2nd Preliminary Consultation
MONTGOMERY COUNTY HISTORIC PRESERVATION COMMISSION
STAFF REPORT

Address:	9 Chevy Chase Circle, Chevy Chase	Meeting Date:	6/24/2020
Resource:	Master Plan Site #35/13-001A Newlands-Corby Mansion	Report Date:	6/17/2020
Applicant:	Adrienne Arshat Revocable Trust (Phillip Long, Architect)	Public Notice:	6/10/2020
Review:	2 nd Preliminary Consultation	Tax Credit:	N/A
Case Number:	35/13-001A-20C	Staff:	Michael Kyne
PROPOSAL:	Fencing and garage alterations

1 PROPOSED ELEVATION - CONNECTICUT AVENUE

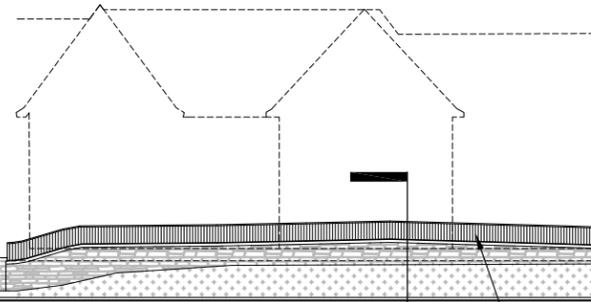
Although the fencing proposal has been substantially revised, staff remains concerned about the visibility of the historic house from the public rights-of-way. The proposed 3' tall stained solid wooden board fence on top of the existing 30" tall stone wall will result in a 5'-6" tall solid fence on the west (Connecticut Avenue) and south (Chevy Chase Circle) sides of the property. While the proposed 5' tall fence on the east (Brookville Road) side of the property will be an alternating (50% open) wooden board fence, staff finds that it will significantly reduce the visibility of the property from the public right-of-way of Brookville Road. Accordingly, staff reiterates the Commission's recommendations regarding fencing/screening at the May 27, 2020 HPC meeting (see Page 4).

PREFERRED OPTION

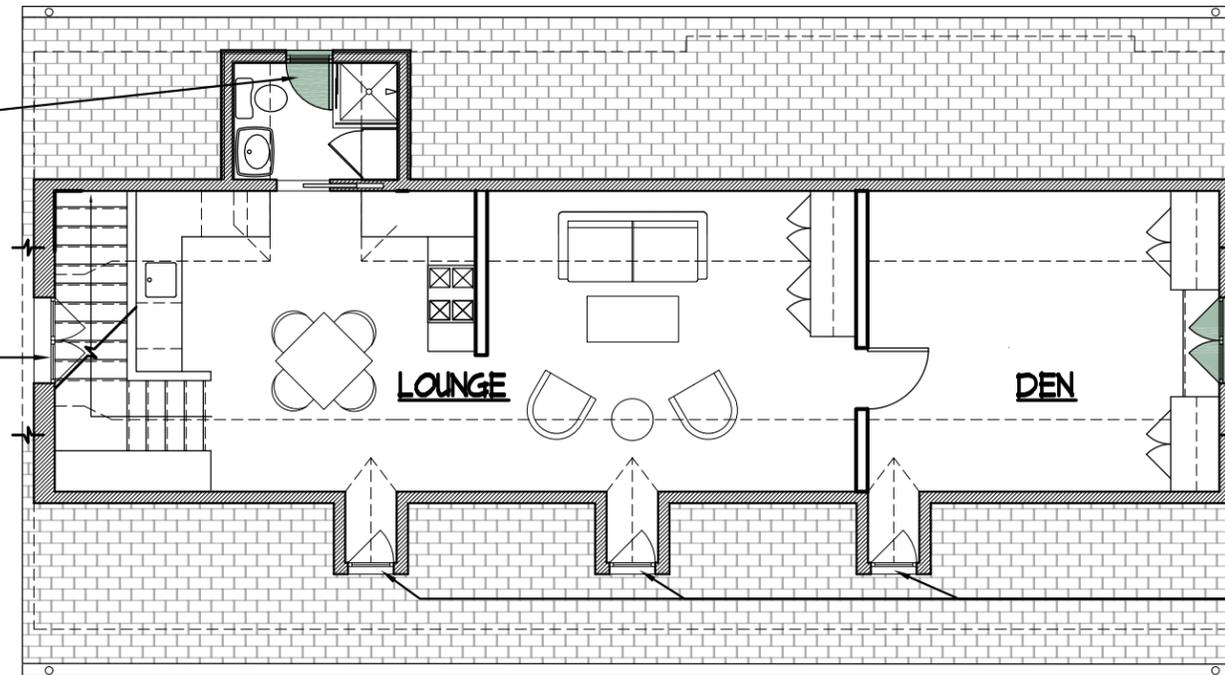
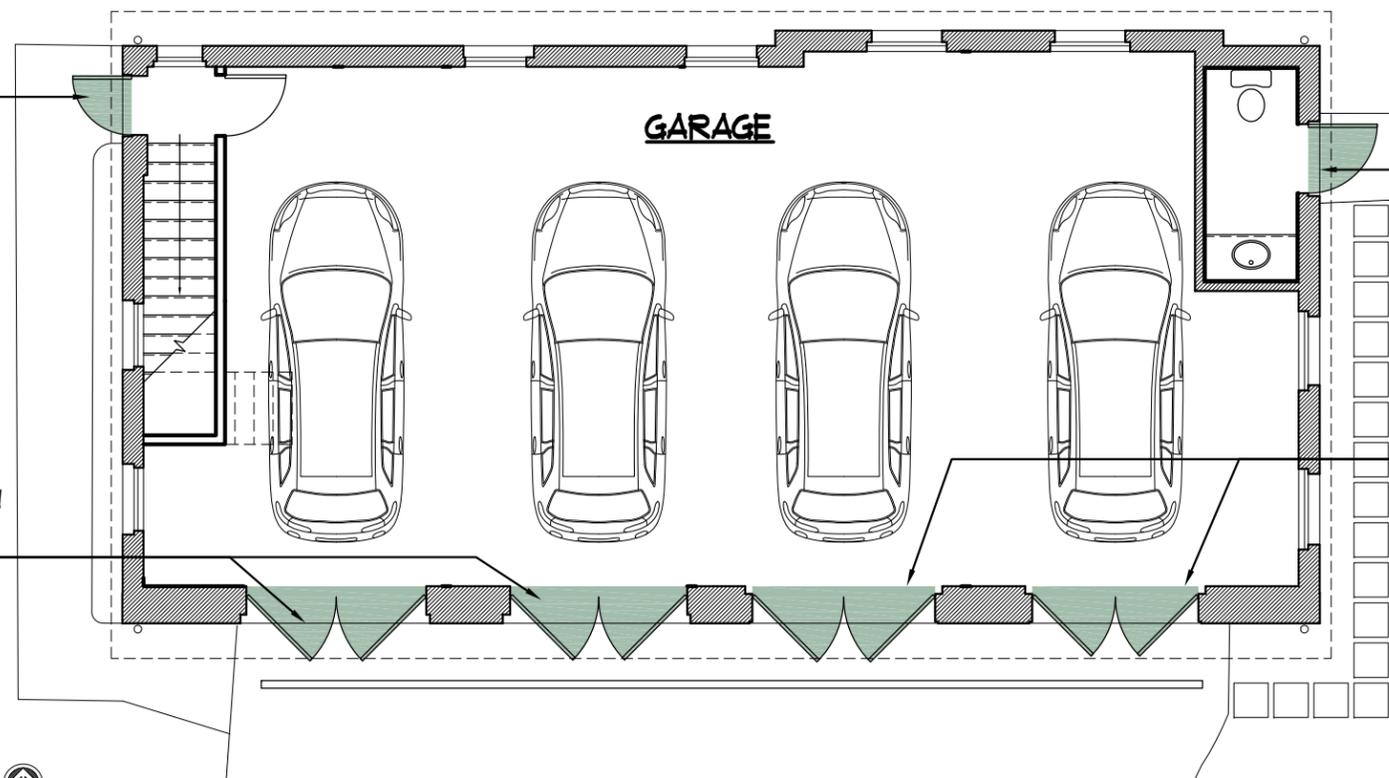
- Although the HPC previously stated that the removal of the east windows/installation of egress windows on the east elevation was inappropriate, as it removes character-defining features, the applicants continue to propose this alteration.

ALTERNATE OPTION

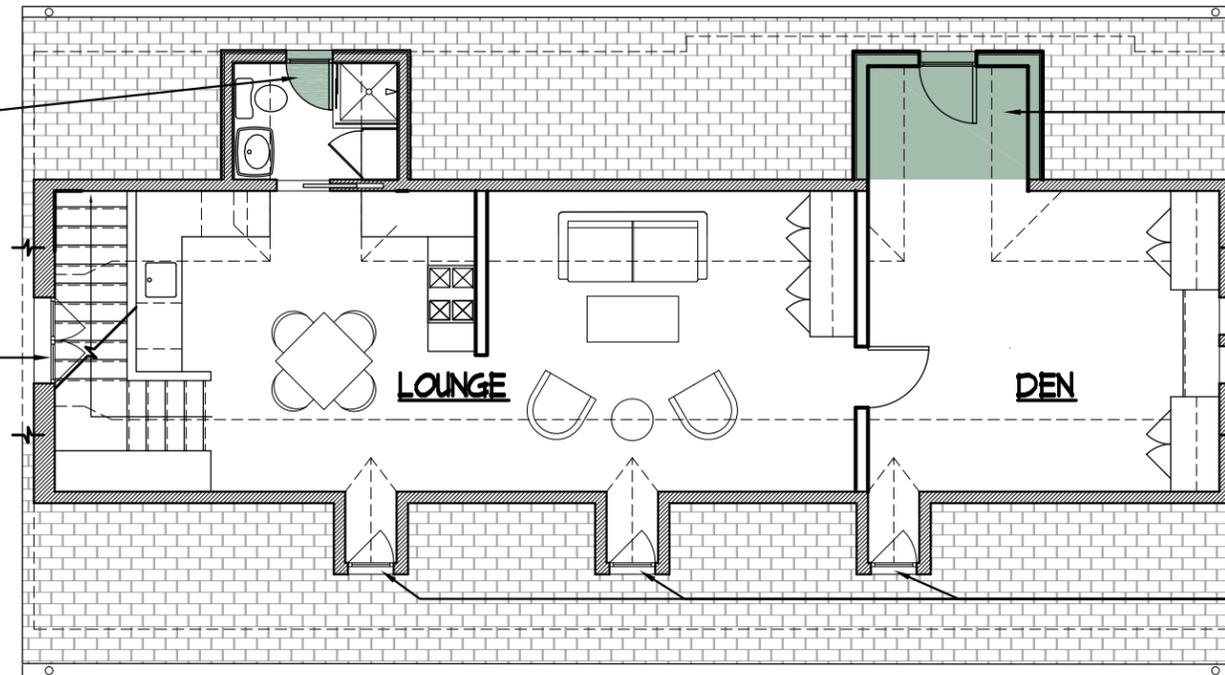
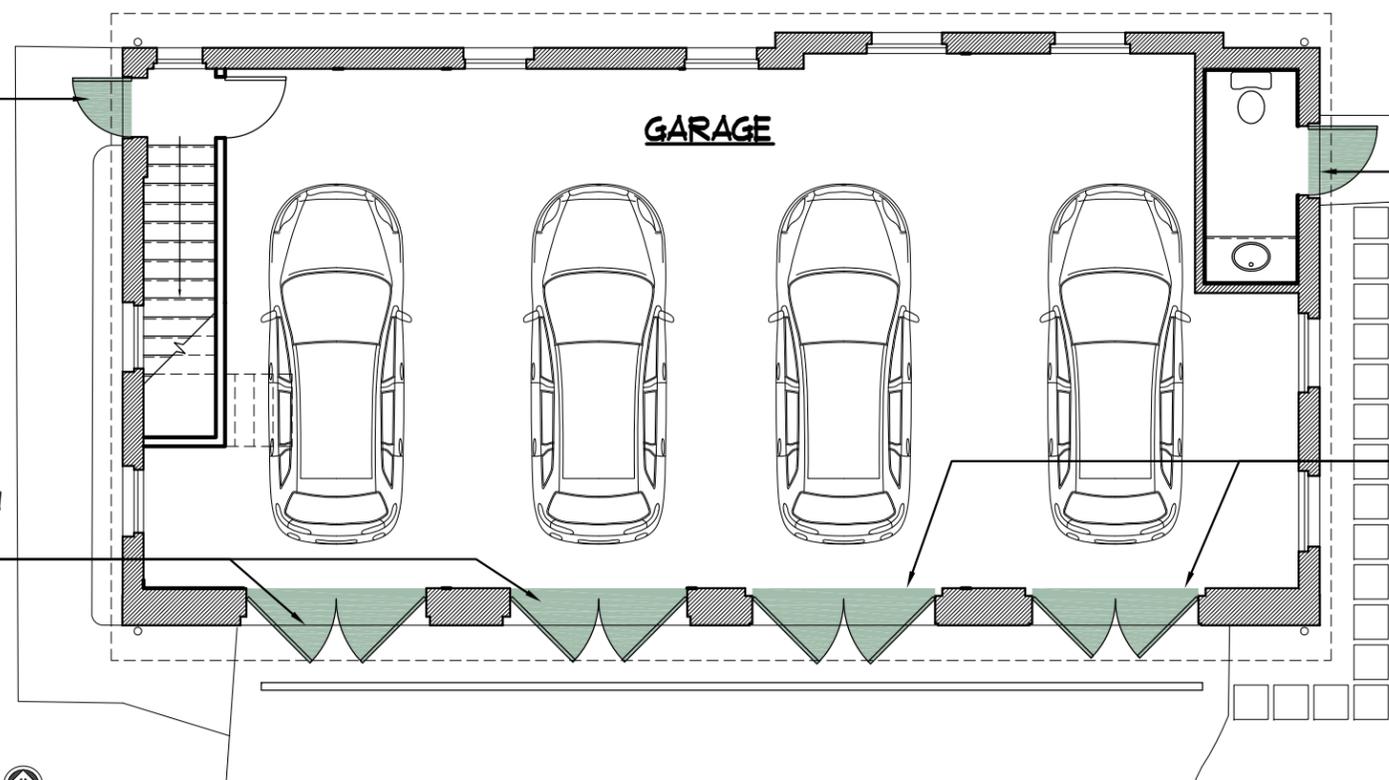
- As an alternative, the applicants have proposed the construction of a second gable dormer with egress on the north elevation to match the existing dormer. This option is consistent with the HPC's guidance at the March 25, 2020 preliminary consultation.

In accordance with the HPC's recommendations at the March 25, 2020 preliminary consultation, staff supports the proposed garage alteration with the alternative second gable dormer with egress on the north elevation.
